NO	ISSUE	DATE
4	ADDENDUM 4	04/23/10
9	MODA - FOR CONSTRUCTION	09/14/10
10	ADDENDUM 14	10/11/10
11	ADDENDUM M01	12/08/10

GROUND LEVEL PLAN - MODA

Sheet
A-220

1 GROUND FLOOR PLAN - MODA

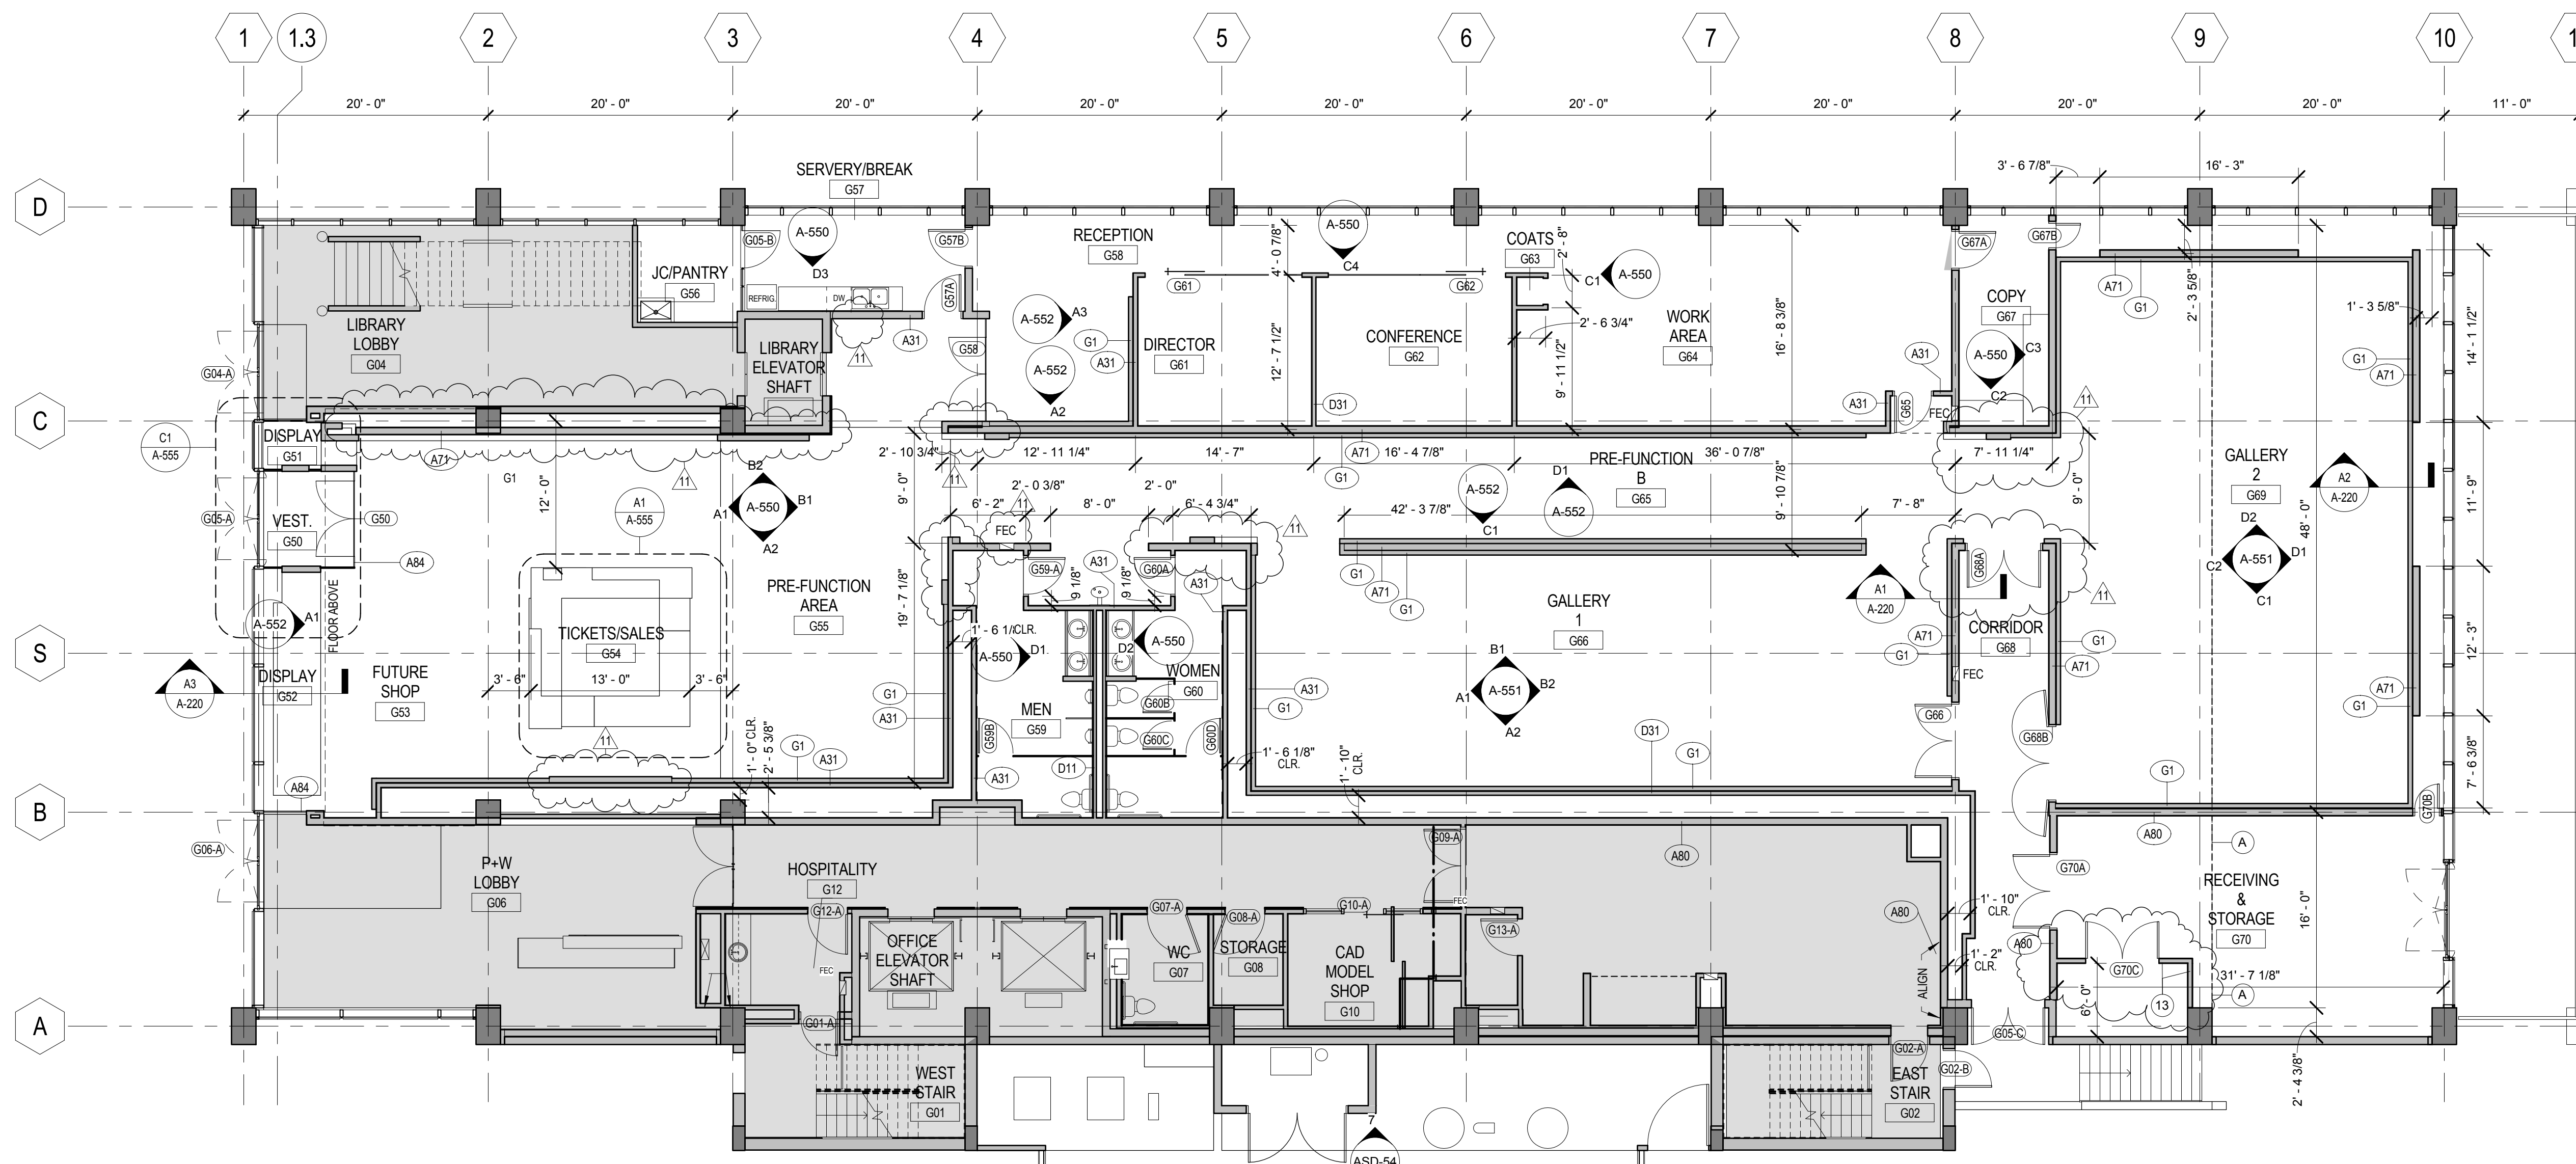
A. BETWEEN FIRST AND SECOND FLOOR, PROVIDE A 1-HOUR PARTITION TO THE MODA SIDE OF THE LIBRARY AT THE INTERIOR GLAZING. REQUIRED TO COMPLETE 1-HOUR RATING FOR THE STORAGE ROOM.
